SERVICE BULLETIN

DATE: 15 JUNE 1990
PAGE 1 OF 3

SUBJECT: ONE-TIME REPLACEMENT OF TAIL ROTOR BLADE PITCH ARM BOLT ATTACHING NUTS.

MODELS AFFECTED: All MD Helicopters, Inc. (MDHI) 369 Series helicopters, equipped with metal tail rotor blades.

Figure 1. Replacement of Tail Rotor Pitch Link Nuts.

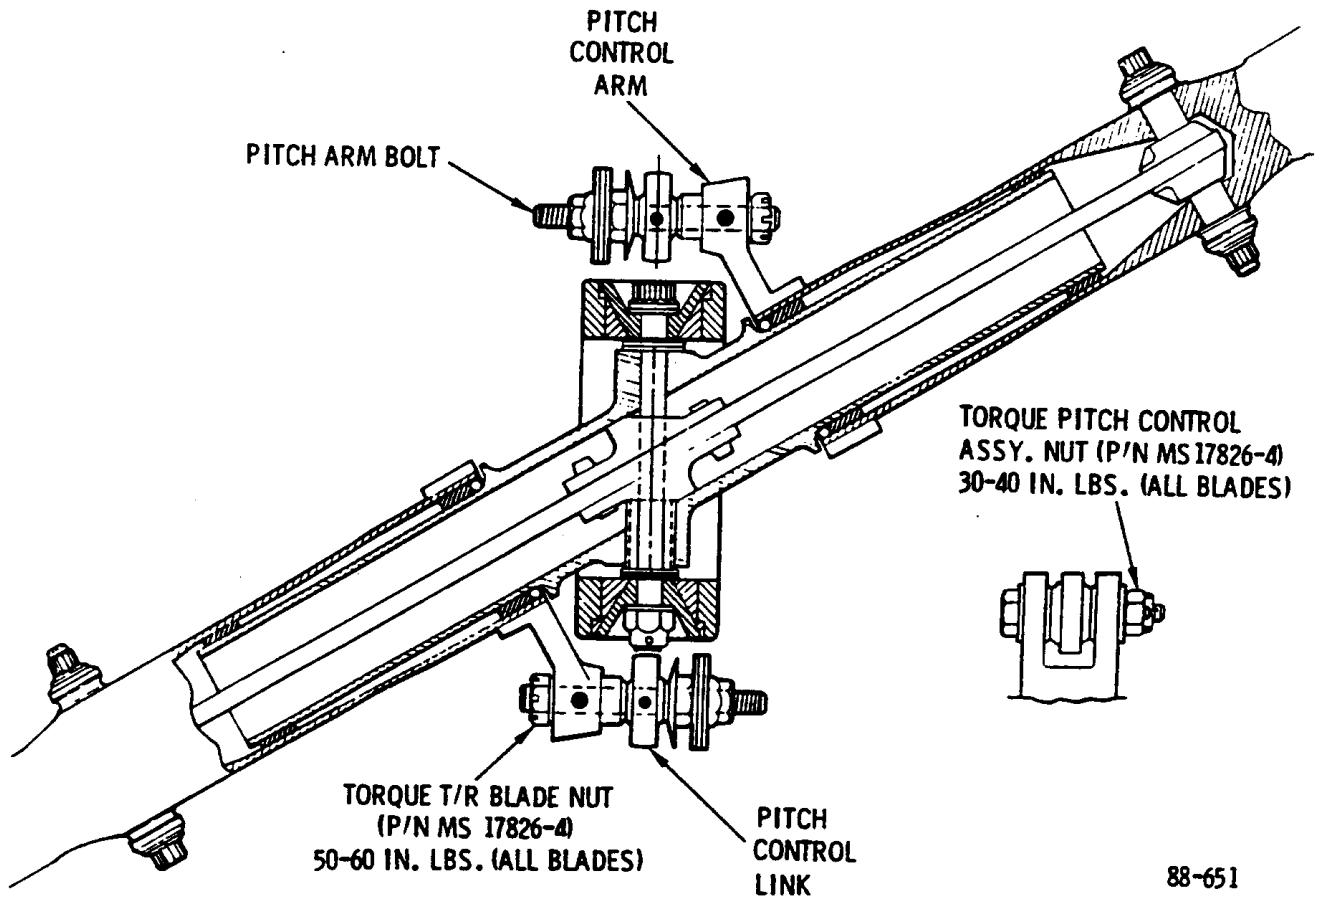
PREFACE: MDHI installation requirements were recently revised to lower the installation torque of the tail rotor pitch link nuts. Therefore, MDHI is requiring operators to replace the subject MS17826-4 nuts. MDHI will provide operators with replacement nuts, free of charge. Contact a MDHI Approved Service Center or Distributor for replacement nuts.

- a. Remove nuts at pitch control assembly and nuts at tail rotor blade pitch arm attachments. (Refer to Figure 1 .)
- b. Install new MS17826-4 nuts. Torque tail rotor blade nuts to **50 - 60 inch-pounds**. Torque nuts at pitch control assembly to **30 - 40 inch-pounds**.

DO NOT exceed 60 inch-pounds torque on the tail rotor blade nuts or 40 inch-pounds on the pitch control assembly nuts.

- c. Without exceeding torque limits, align cotter pin hole at the outboard and inboard ends of the pitch arm and install cotter pin.

Apply MIL-P-8585 zinc chromate primer to cotter pin during installation.
